Errata disclaimer: This Errata applies to SLG46108 revision YA.

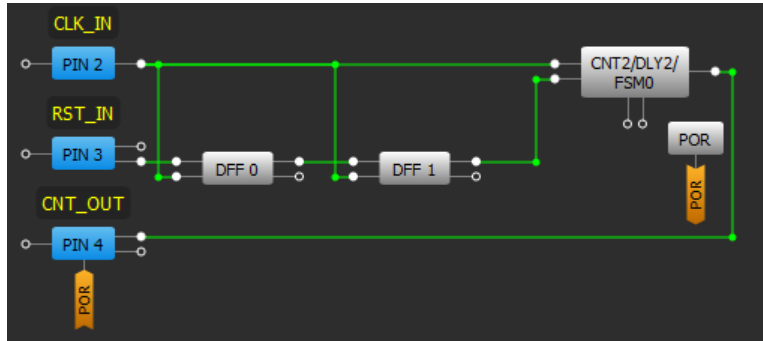
If the Counter Reset is asserted at the same time as a rising clock edge, it is possible that the Counter Data will be reset incorrectly and the counter output may appear faster than expected. This phenomenon appears more often as the clock frequency increases.

- Synchronize the RESET input of the Counter with its CLK using 2 DFF cells as shown in the image below.

## OSC Accuracy vs VDD

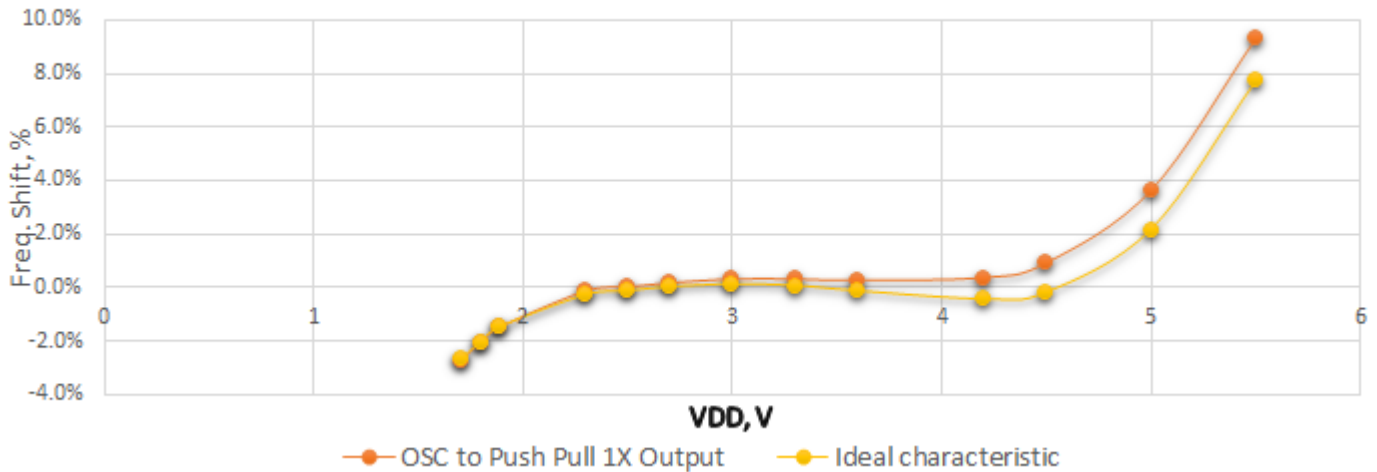
While applying some high frequency noise to the VDD, OSC inaccuracy may increase. The same behavior is also present in cases where high frequency switches are outputted from the chip using the Push Pull type driver. See, test results below.

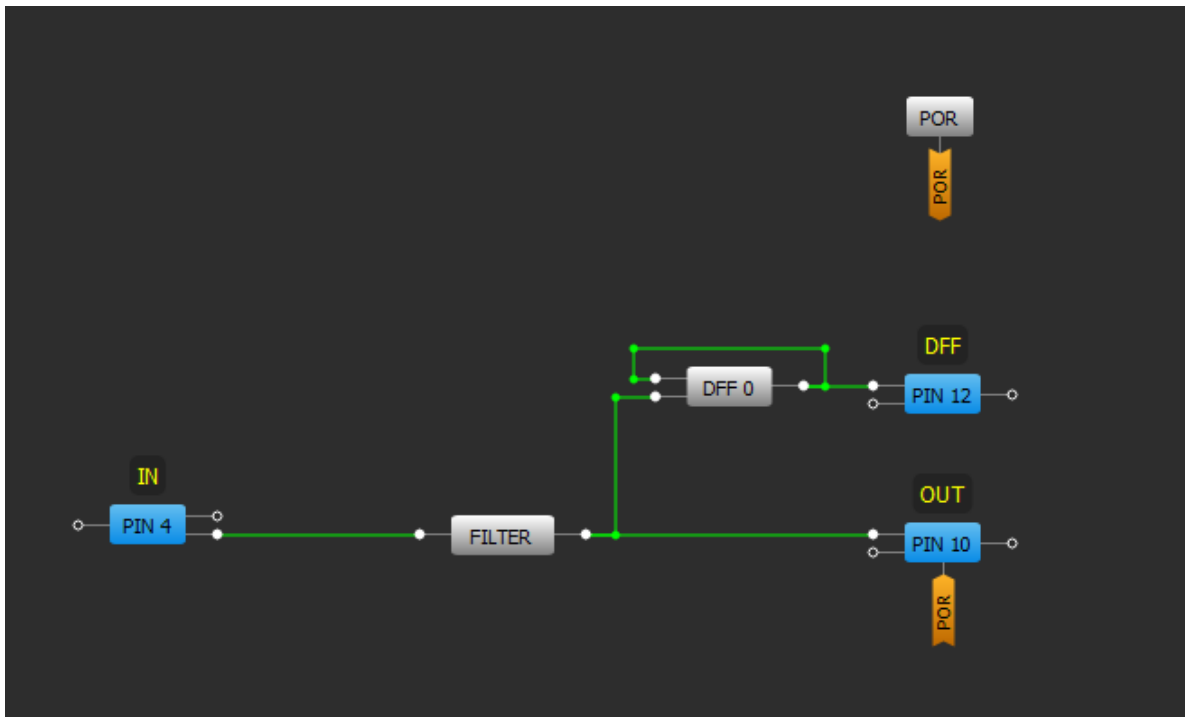
However the issue can be minimized by doing the following:

- Only use frequencies lower than 2 MHz when switching the output
- Do not use parallel PIN connections to output high speed switching signals.

Channel 1 (yellow/top line) – PIN#4 (IN)  
Channel 2 (light blue/2nd line) – PIN#10 (OUT)  
Channel 3 (magenta /3rd line) – PIN#12 (DFF)

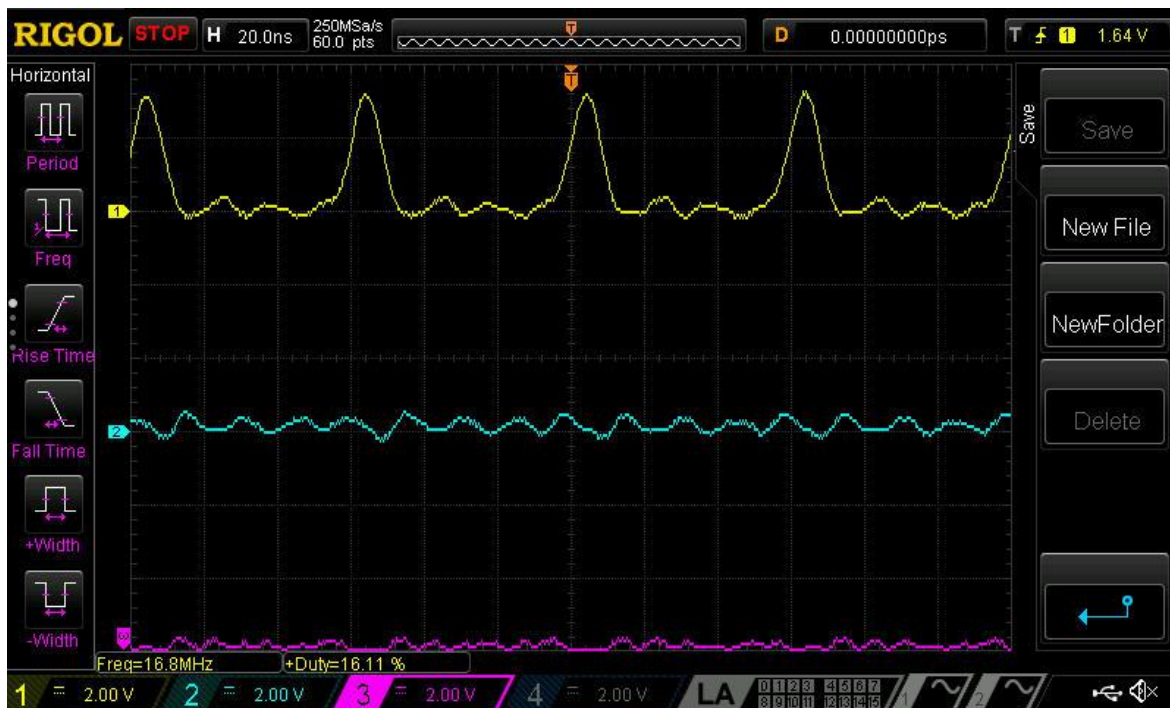
If clock type high frequency input comes in, the FILTER cell may not filter out it. There are several factors like input frequency, duty cycle and LOW duration in such signal that may lead to its passing through FILTER block.

1. Period is 60ns. Pulse width is 10ns DC=16.7% (Correct functionality)

2. Period is 60ns. Pulse width is 20ns DC = 33.3% (Incorrect functionality)

3. Period is 60ns. Pulse width is 30ns DC=50% (Incorrect functionality)

4. Period is 60ns. Pulse width is 40ns DC=66.67% (Correct functionality)

Currently there is no workaround for this issue. Filter block is good at filtering short spontaneous glitches. It is intended to be used in series connection before the delay cell to avoid its latching (see issue #3).
